TITLE 32—NATIONAL DEFENSE

The following policies and rules, which require modifications of aircraft for the purpose of remedying defects affecting airworthiness, are hereby adopted. They shall become effective upon publication in the **FEDERAL REGISTER** unless otherwise indicated, in order to promote safety of the flying public. Compliance with the notice, procedures, and effective date provisions of section 4 of the Administrative Procedure Act would be impracticable and contrary to the public interest and, therefore is not required.

3. AIRCRAFTNESS directives which remain in effect (CAA rules). Modifications and inspections of civil aircraft, as described below, are mandatory. Aircraft which are not modified and inspected as required herein are considered unairworthy, and continued flight of such aircraft will be regarded as violations of the Civil Air Regulations.			602-20 and 21, for cracks between the attachment bolt holes. The inspection should be conducted with at least a four power magnifying glass at each periodic inspection not to exceed 450 hours flight time. A more detailed inspection should be made at the time of removal of the wings for the wing doublets specified

FIGURE 1.

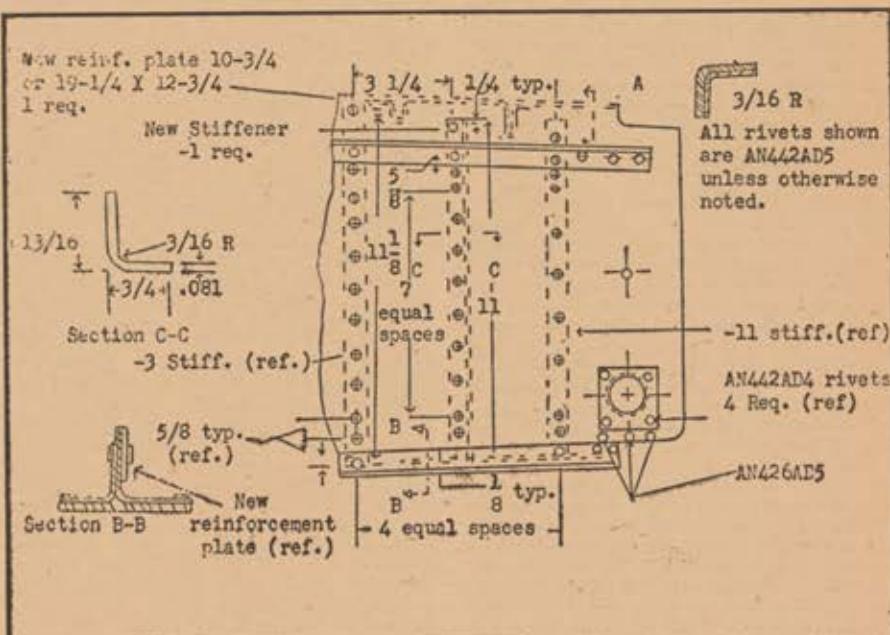
(1) Remove the first and second stiffeners forward of the rear spar, parts -3 and -11 in figure 1.

(2) Remove all rivets through the rib in the area from the rear spar to the forward of the two stiffeners removed, except the rivets through the bottom flange of the rib.

(3) Replace the original reinforcement plate with a new reinforcement plate made of 0.051-inch 24ST alclad. The new reinforcement plate should be 10 $\frac{1}{4}$ inches long and otherwise should be in accordance with figure 1.

(5) Install a new stiffener made of 0.081-inch 24ST alclad to the dimensions and at the location shown in figure 1.

FIGURE 2.

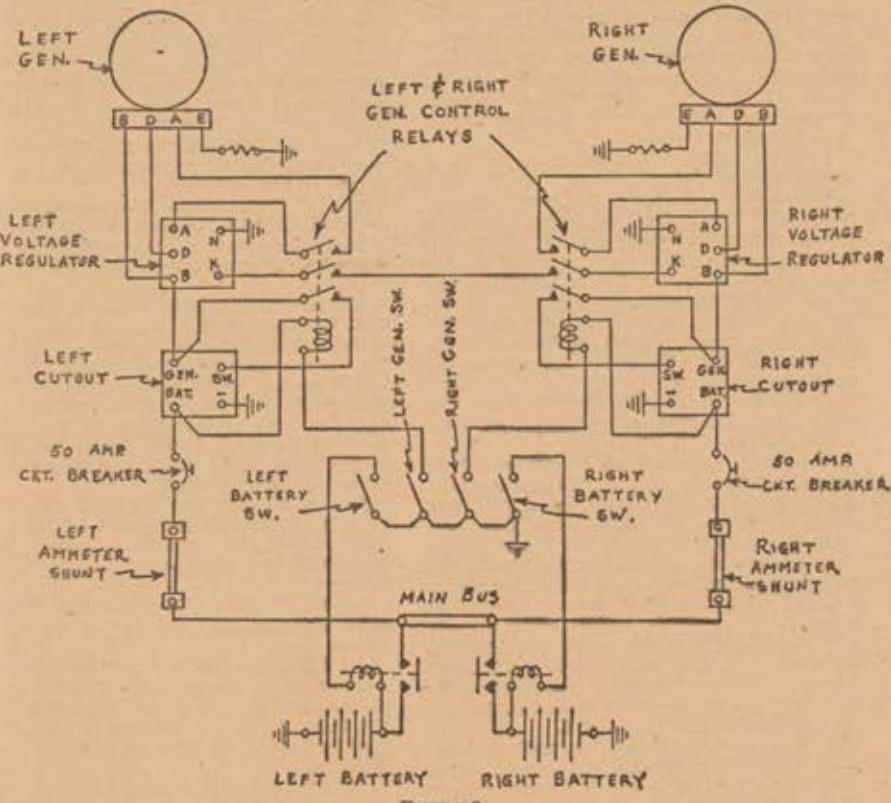
To be accomplished prior to certification or, if certificated, on next periodic inspection but not later than October 1, 1947. In accordance with Figure 2 (Page 30) install a three-pole-single-throw relay, General Electric No. CR2791-B100G3 or equivalent, for the control of each generator. The operating coil of the left generator relay should be controlled by a single-pole-single-throw "On-Off" switch mounted on the pilot's control panel adjacent to the left battery switch, and should be labeled "Left Gen. Sw.". The operating coil of the right generator relay should be controlled by a single-pole-single-throw "On-Off" switch mounted on the pilot's control panel adjacent to the right battery switch and should be labeled "Right Gen. Sw.". The battery and generator switches should be located adjacent to each other in the order shown on Figure 2, and should be provided with a suitable gang-bar such that pilot can throw the four switches to the "Off" position in a single operation.

To be accomplished prior to certification or, if certificated, on next periodic inspection but not later than October 1, 1947. In accordance with figure 2 install a 50-ampere trip-free circuit breaker, Spencer Thermostat Co. PLM-50 or equivalent, between the battery terminal of each generator cut-out and its respective ammeter shunt. The circuit breakers should be accessible in flight and labeled respectively: "LEFT GEN. CIRCUIT" and "RIGHT GEN. CIRCUIT."

FIGURE 3.

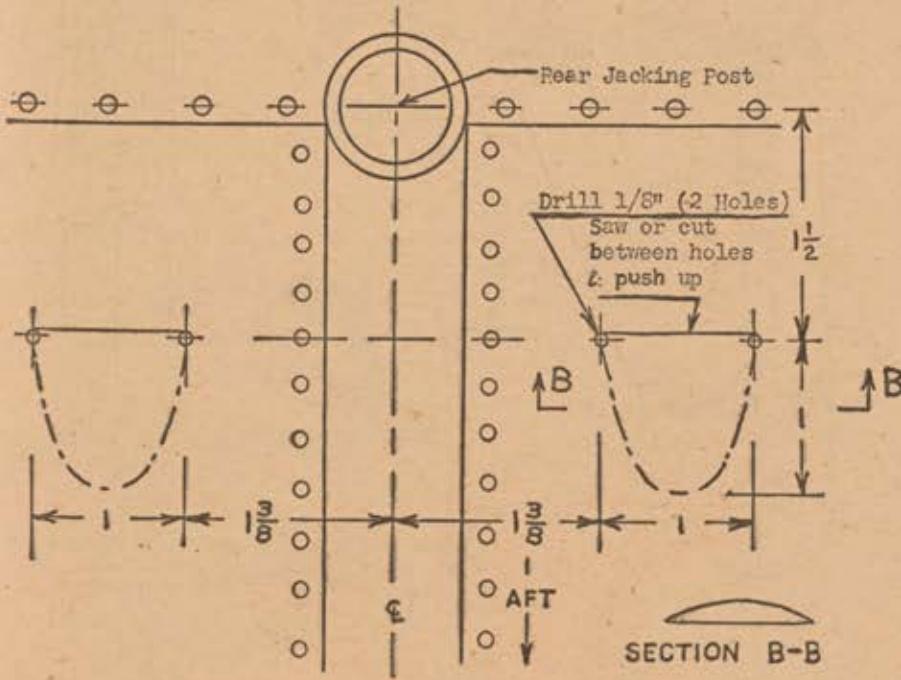
No. 15 as shown in figure 3. (Beech Service Bulletin No. C18-7 covers this same subject.)

FIGURE 8.

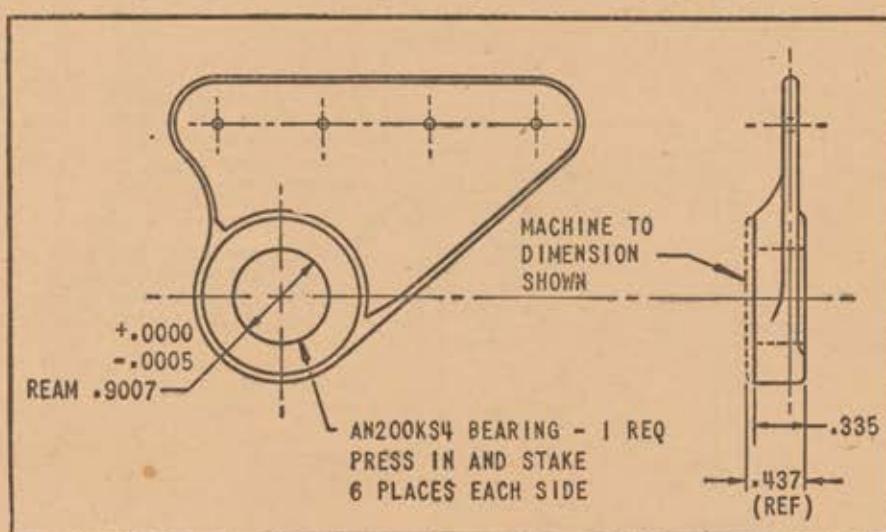
1. Machine face of boss on fitting assemblies part Nos. 4154028 and 4154028-1, to 0.335 inch, and ream bore to 0.0007 plus 0.0000, minus 0.0005 inch. (See fig. 8. Replace bearing AN209K4A with self-aligning bearing, part No. AN200KS4 and stake in six places each side. Install reworked fitting assemblies, part Nos. 4154028 and 4154028-1, on original bulkheads as follows:

FIG. 11

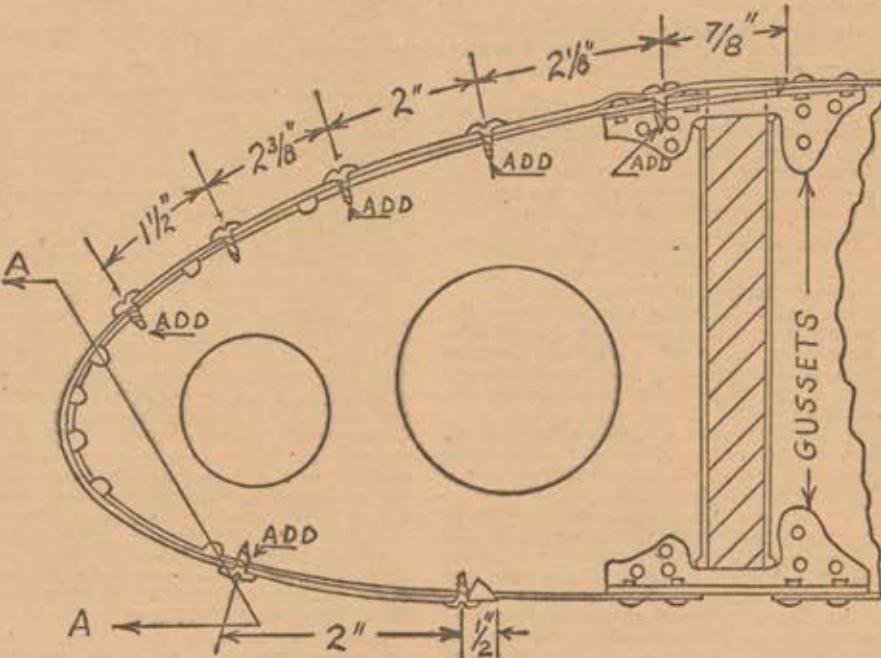
Compliance required by March 1, 1948. Inspect the wing leading edge for buckled nose ribs or loose PK screws by pressing leading edge skin with hand to nose ribs. If the skin can be depressed beyond the normal wing contour, other than the extreme nose radius, indicated by section A-A in figure 11, the fabric should be cut open on the bottom surface just forward of the front spar for thorough inspection. Item No. 1 below should be accomplished on all wings whether damage has occurred or not, whereas Item No. 2 pertains only to damaged ribs found in the above inspection. Repair need not be made if buckling is confined to area forward of section A-A of figure 11.

1. To help prevent further failures of the nose ribs five additional No. 4 x $\frac{1}{4}$ PK screws or, as an alternate, Cherry CR163-4-2 rivets or equivalent are to be installed in all nose ribs. Four PK screws or rivets are to be installed on the top surface and one PK screw or rivet is to be installed in the bottom as shown in figure 15. Apply dope liberally under the PK screw head before tightening. It is not necessary to remove the fabric to accomplish this modification.

2. Damaged ribs should be cut away at the top and bottom of spar. The new nose ribs are installed by means of two gussets on the side of the ribs as shown in Figure 11. Factory kits, Aeronca part Nos. 5-185-2 and 5-190-2, are to be used. (Aeronca Helps and Hints No. 17 with three supplements thereto covers this same subject.)

FIGURE 13.

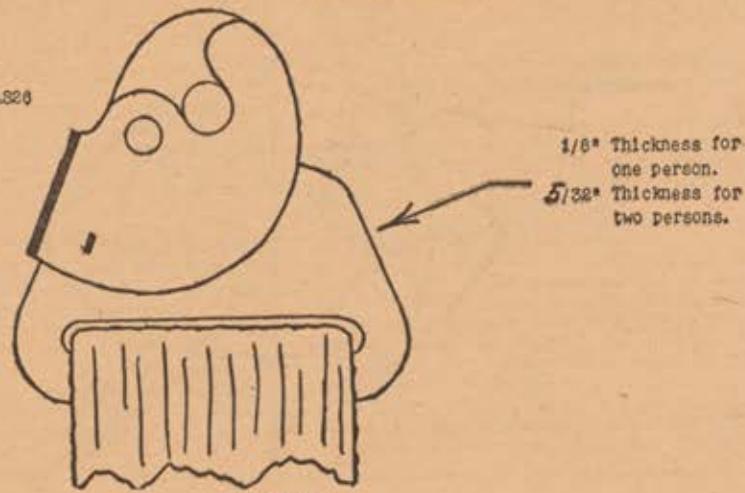
To be accomplished as soon as possible but not later than May 1, 1950. Warren McArthur end fittings, P/N 275-AS26, (Air Associates P/N M-1842) have been found to be of insufficient strength for use in two-person belts. These fittings are not marked, have a fitting plate thickness of $\frac{1}{8}$ inch, and may be identified by comparison with figure 13. Belts using these fittings must be modified so that the label will read "Approved for One Person." This may be done by blanking out the words "or Two" and the letter "s" in the word "Persons" on the label with India ink or an equally effective method. All such belts presently used in two-person applications shall be removed and replaced by other belts approved for two persons.

FIGURE 14.

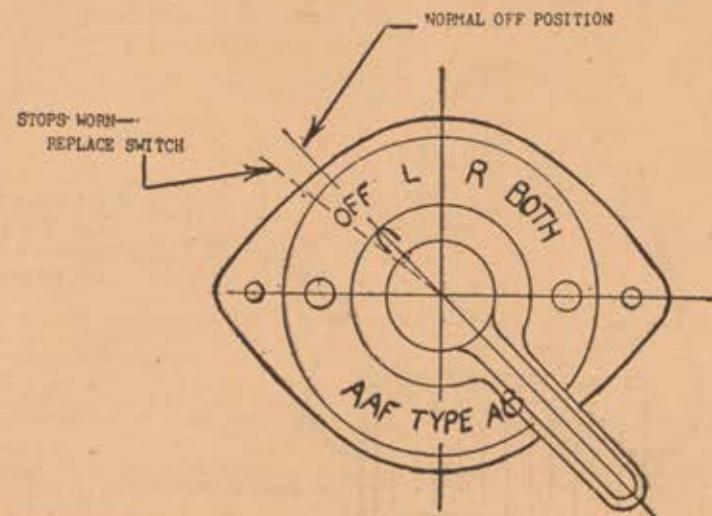
1. Inspection should consist of the following: Check switch lever for overtravel past the "off" position. Figure 14 shows the location of the switch lever in the "off" position. The pointer projecting from the lever points to the middle "f" in the word "Off." When the lever can be turned to a point beyond the centerline of the "O" in the word "Off," the rotation stops have become worn and the switch should be replaced.
